SERVICE INFORMATION NO. SI 20-030

EASA AD 2007-0060R1-E
BRP Rotax 912 Series Engines – Fuel Pump Replacement
ATA-Code: 73

SERVICE BULLETIN
REPLACEMENT
OF FUEL PUMP
FOR ROTAX® ENGINE TYPE 912 (SERIES)
SB-912-053

fig. 1

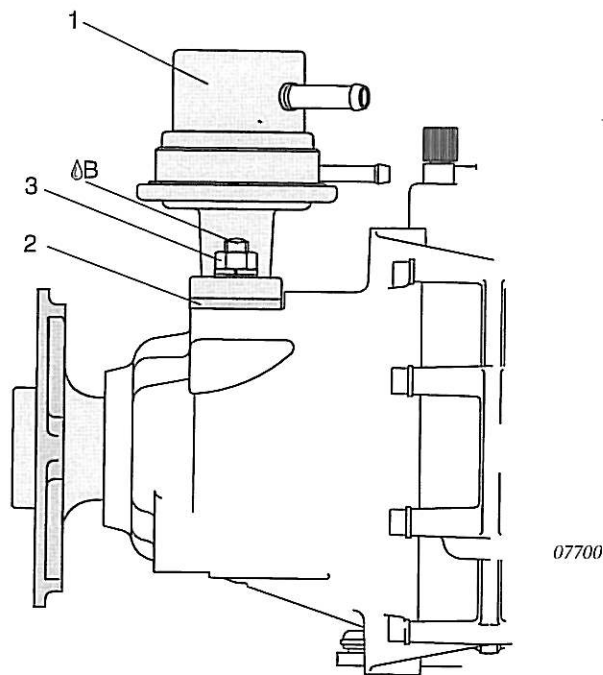
Replacement of fuel pumps with part no. 892230, 892232, 892540 through part no. 892542 and

Replacement of fuel pumps with part no. 892235, 892236, 892545 through part no. 892546 for ROTAX® engine type 912 (Series).

1. Remove fuel pump (1).
2. Gasket (2) replaced by new part.

■ **CAUTION:** Install new gasket supplied with new fuel pump. Do not reuse old gasket.

4. Tighten uniformly hex. nuts (3) with LOCTITE 243. Tightening torque 15 Nm (133 in.lb).
